## Comments for Planning Application: A/YL-KTN/1252

Temporary Open Storage of Metal Scaffolding

with Service Office at Lots 1198ARP(Part), 1198Ass1 & 1198Ass2

Report No.: **LD/L1198A1/DS01(A)**  
Date: **3/9/2026**

## 2. Catchment Area

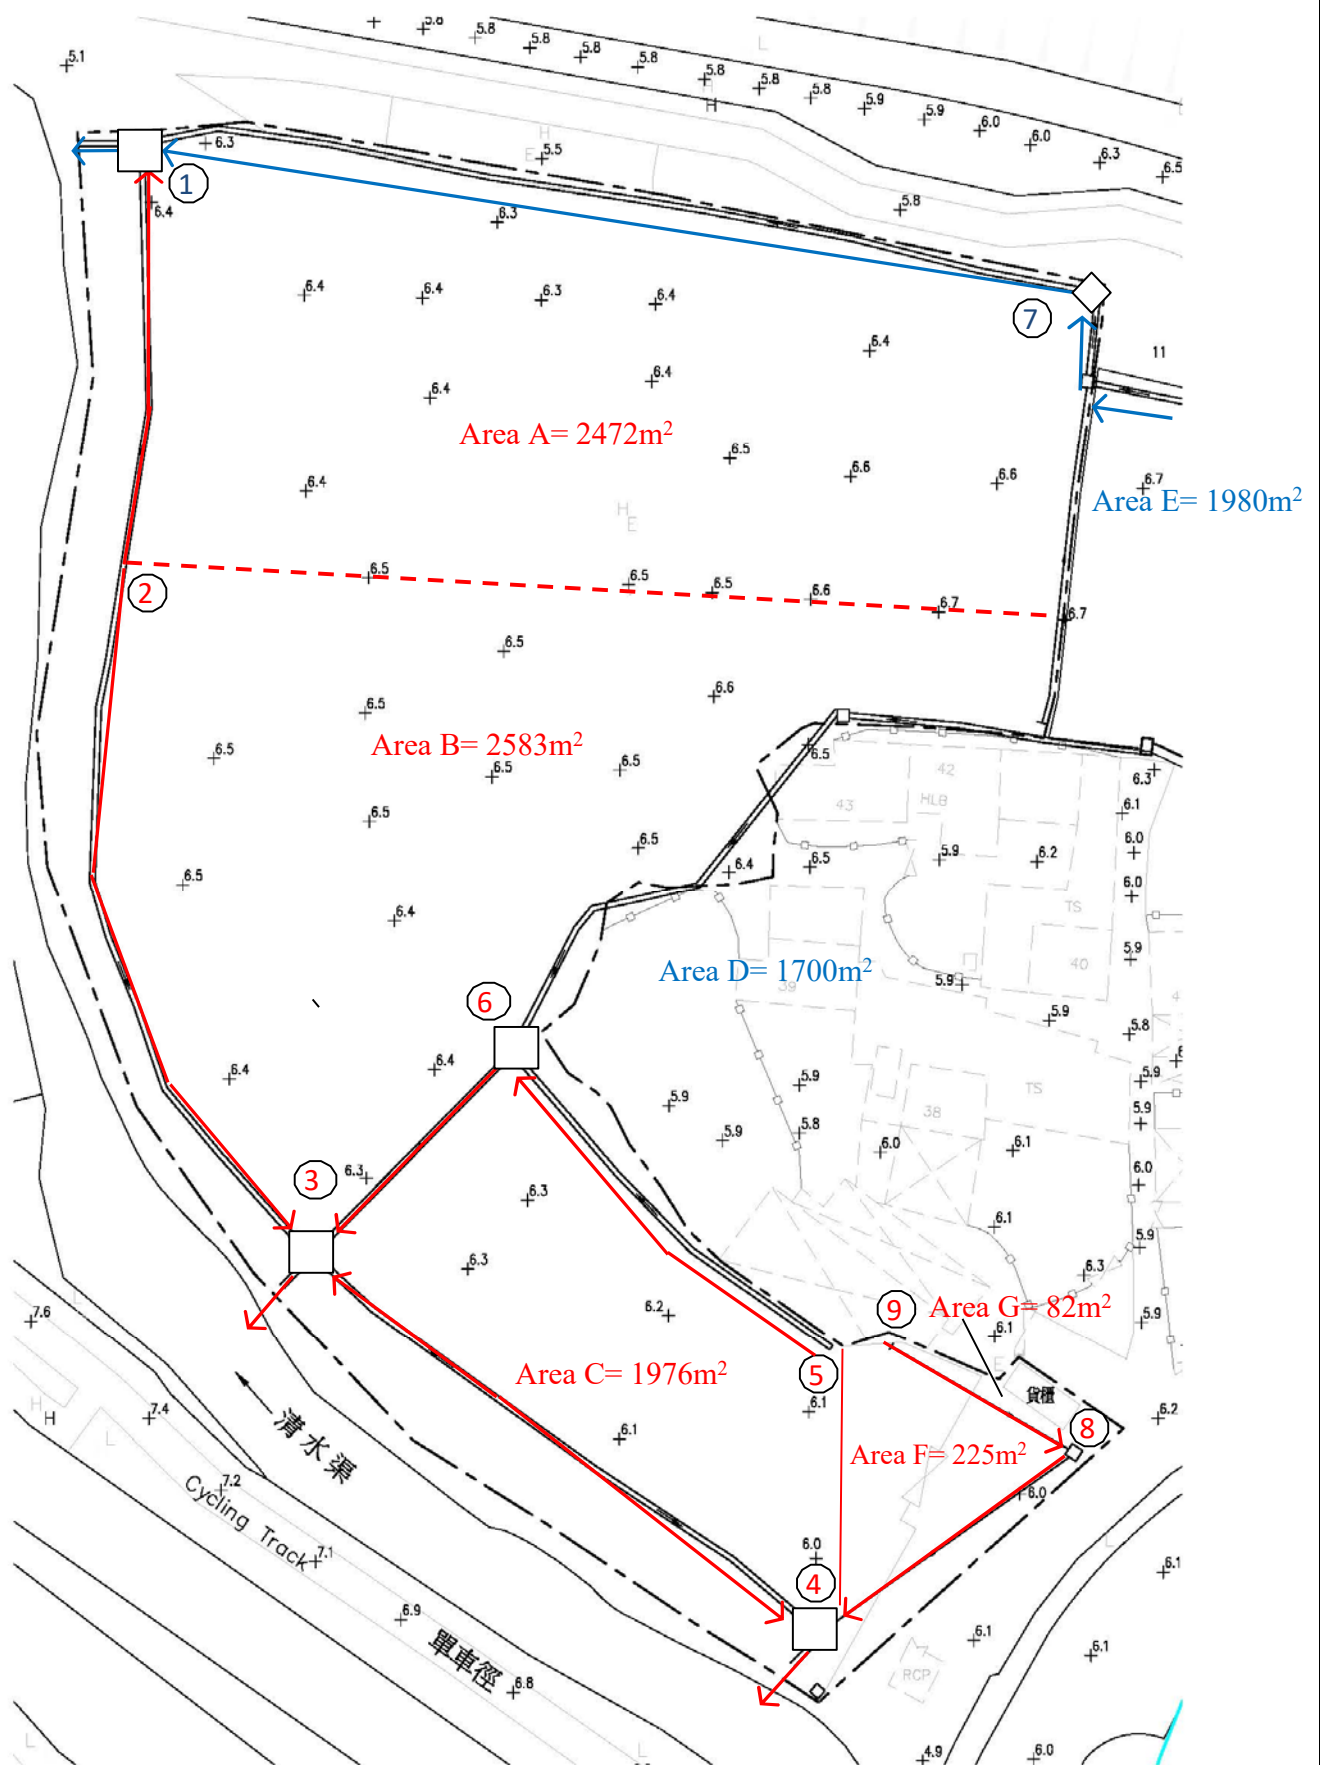
| <b><u>DSD Comments</u></b>                                                                                                                                                                        | <b><u>Response</u></b>                           |
|---------------------------------------------------------------------------------------------------------------------------------------------------------------------------------------------------|--------------------------------------------------|
| 4. Provide hydraulic calculations for the proposed 150mm and 300mm U-channels.                                                                                                                    | 4. Noted and See attached Hydraulic calculations |

The catchment area for the design of surface channels is shown below :
